Service Bulletin

AUGUST

NO. 340

*Studebaker and
Packard*

Fig. 1

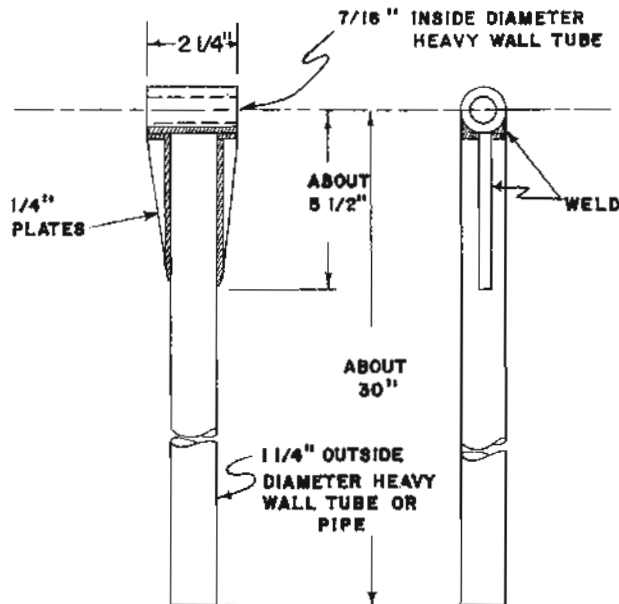
With reference to alignment of the rear shock absorbers and bushing replacement as covered by the articles in Service Bulletin Nos. 336 and 338, Figure 1 provides a sketch of a suggested tool that may be easily fabricated for bending the rear frame cross member when such procedure is required to obtain satisfactory rear shock absorber alignment.

Fig. 6

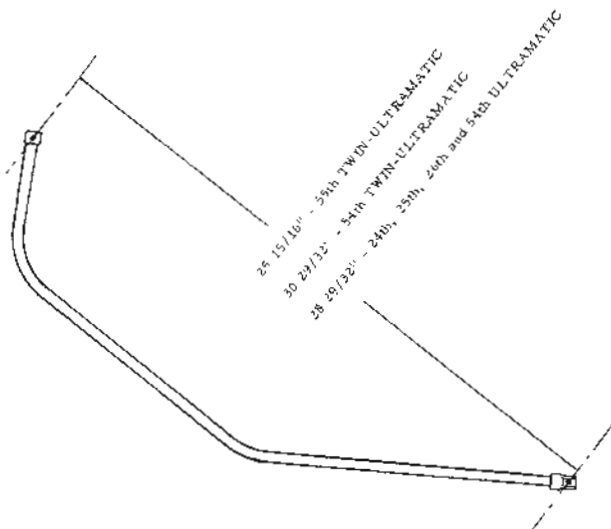
Because of the shape of this rod, it is difficult to determine if it is bent. Its function is to control throttle pressures, clutch engagements and upshifts. Therefore, it is very important that the rod is of proper length. Figure 6 shows the manner in which the rod should be checked and the proper lengths for the various models.

Fig. 7

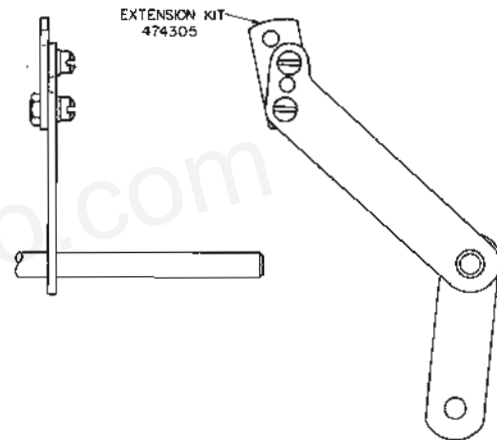
Unexpected or unwanted kickdown into low range converter range when driving at full throttle or near full throttle position may be encountered in some 55th Series Twin-Ultramatic Transmissions.

Because of the stack-up of tolerances in the throttle linkage and adjustments, the throttle valve kickdown position is being reached before the carburetor throttle valves are fully open.

To take care of the slight variations, the linkage geometry can be changed by installing an extension on the throttle control cross shaft lever as shown in Fig. 7.

After installing the extension, readjust all of the linkage as described on pages 52 and 53 in the Twin-Ultramatic section of your 1955-56 Service Manual. Under 'Adjusting Accelerator Linkage - 55th-56th Series' in this article is described an easy method for checking and setting the linkage in the engine compartment.

Part No. 474305, Carburetor Control Cross Shaft Lever Extension Kit is available from your Parts Depot.

FIG. 8

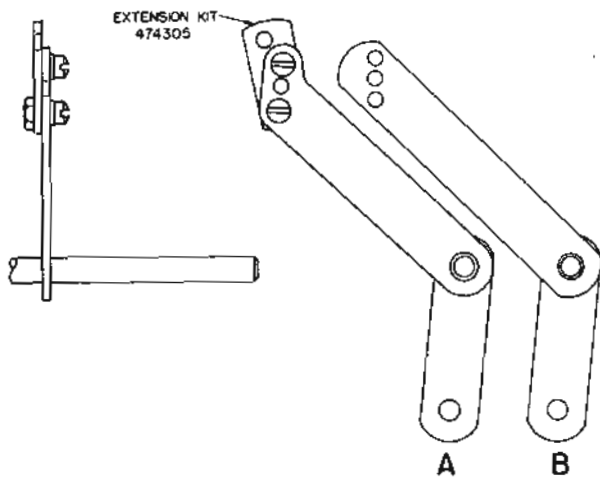
Some early 56th Series cars had the 55th Series throttle lever 'A' as shown in Fig. 8. Some of these may be equipped with Extension Kit, Part No. 474305; depending on unwanted kickdown or too-easy-a-squeeze-out with wide open throttle.

If unwanted kickdown or squeeze-out is encountered on 56th Series cars equipped with 55th Series lever, install the Extension Kit 474305 and readjust the linkage as per the Service Manual.

All 56th Series cars having the throttle lever as indicated by 'B' in the illustration do not require the extension.

Fig. 9

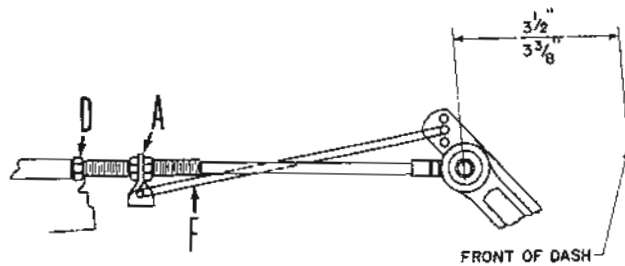
Loosen or back-off the lock nuts on both sides of adjuster 'A'. With the carburetor idle speed adjusting screw against its stop, loosen the lock nut 'D' and adjust the length of the rod to obtain 3-3/8" to 3-1/2" measurement from the front side of the dash. Measure from the bottom of the reinforcement channel in the front side of the dash to the center of the screw in the lever as shown in Fig. 9.

Apply a slight forward pressure on the carburetor transmission cross shaft-to-adjuster rod 'F' and move up the rear lock nut and tighten. Make sure that the alignment of the adjuster is such that it does not cause the lever to bind.

In the 56th Series with the type of lever as shown, if the kickdown is premature, move the adjuster rod into the upper hole in the lever and reset the linkage. If 'flare' exists, move the adjuster rearward 1/16" to 3/32".
